## AGENDA

### PLANNING & ZONING COMMISSION REGULAR MEETING TUESDAY, AUGUST 20, 2024 - 3:30 PM MCALLEN CITY HALL, 1300 HOUSTON AVENUE CITY COMMISSION CHAMBERS, 3<sup>RD</sup> FLOOR

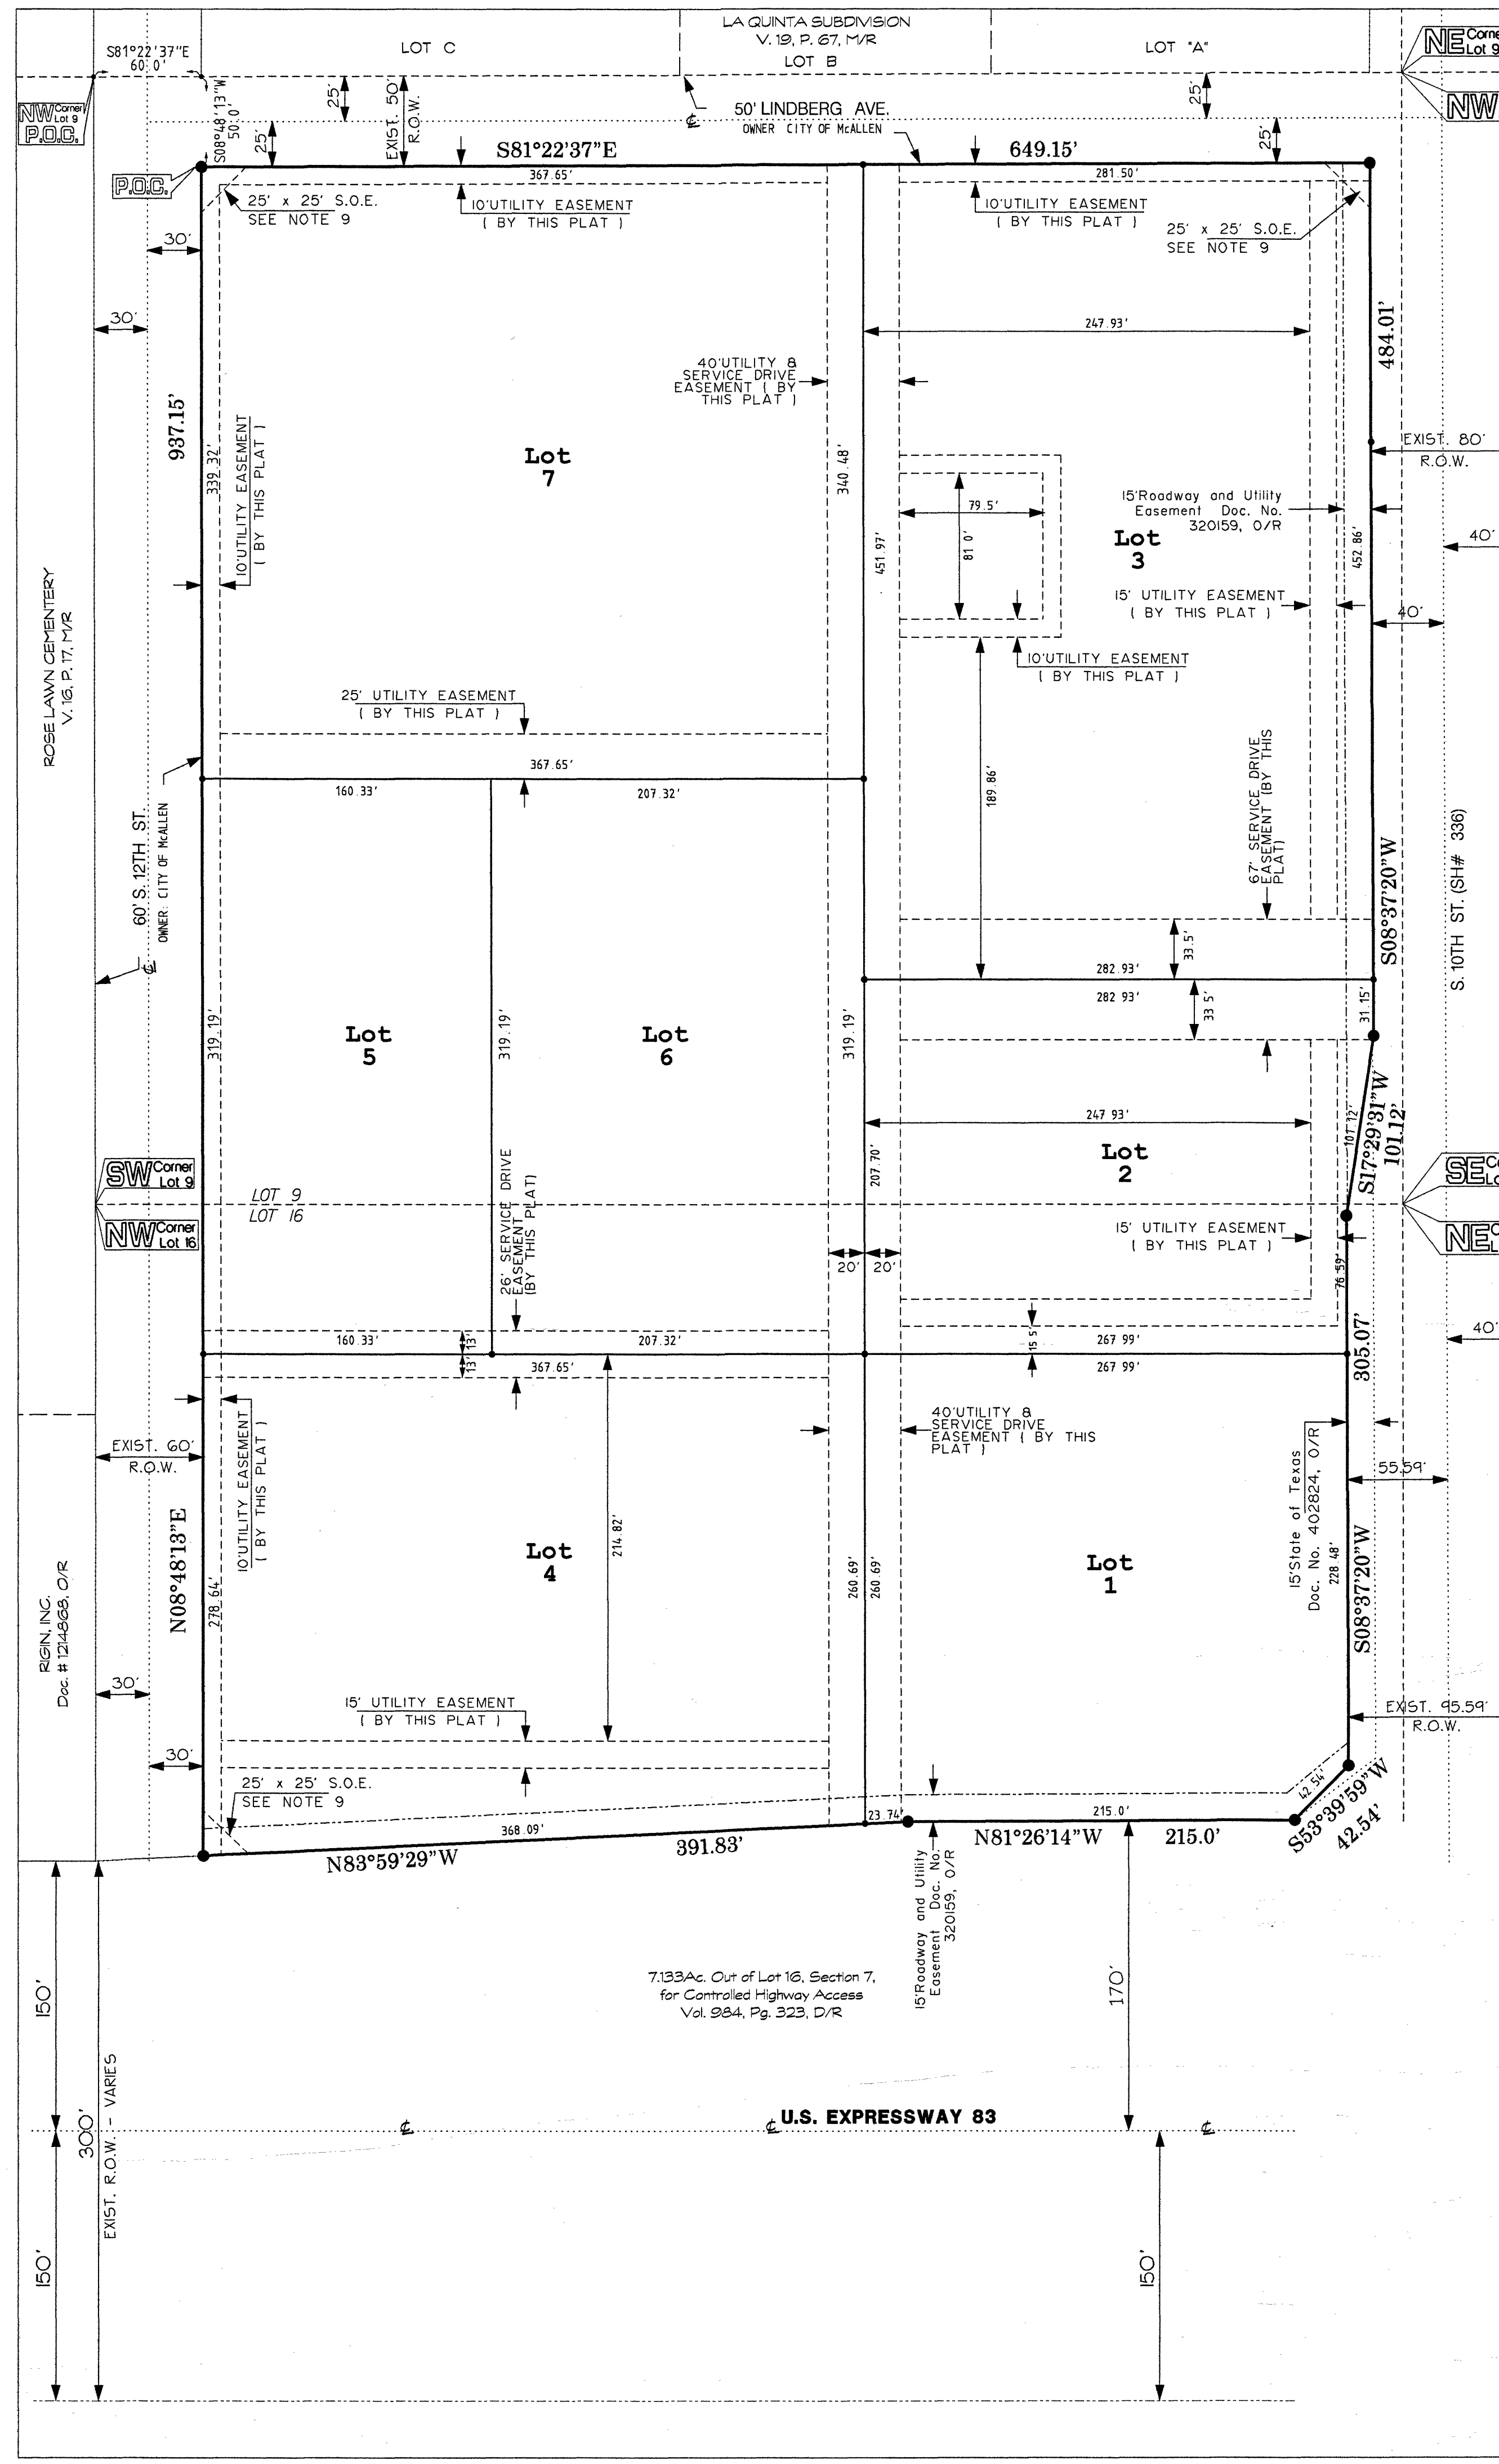
- Show ROW dedication as noted above or submit a variance request for staff review and possible Board's action prior to final.

- Provide a copy of the roadway and easement document referenced on the plat for staff review prior to final.

- Show the total ROW and ROW from the centerline after dedication prior to final.

- Reference the document number for the existing ROW on the plat and provide a copy for staff review prior to final.

- There is a 15 ft. Roadway and Utility Easement shown being part of Lot 3 by a separate document. Provide copy for staff review and clarify if it is part of Street ROW. If it is, it should not be shown as part of Lot 3. Clarify & revise as applicable prior to final.

- Show the ROW dedication as noted above or submit a variance for staff review and possible Board's action prior to final.

- Reference the document number on the plat for any existing ROW and provide a copy of the plat for staff review prior to Final.

- Clarify/remove the E/W solid line shown on the south side of S. 12th Street and the dashed line shown on the north side of S 12th Street prior to final. Review and revise as applicable prior to final.
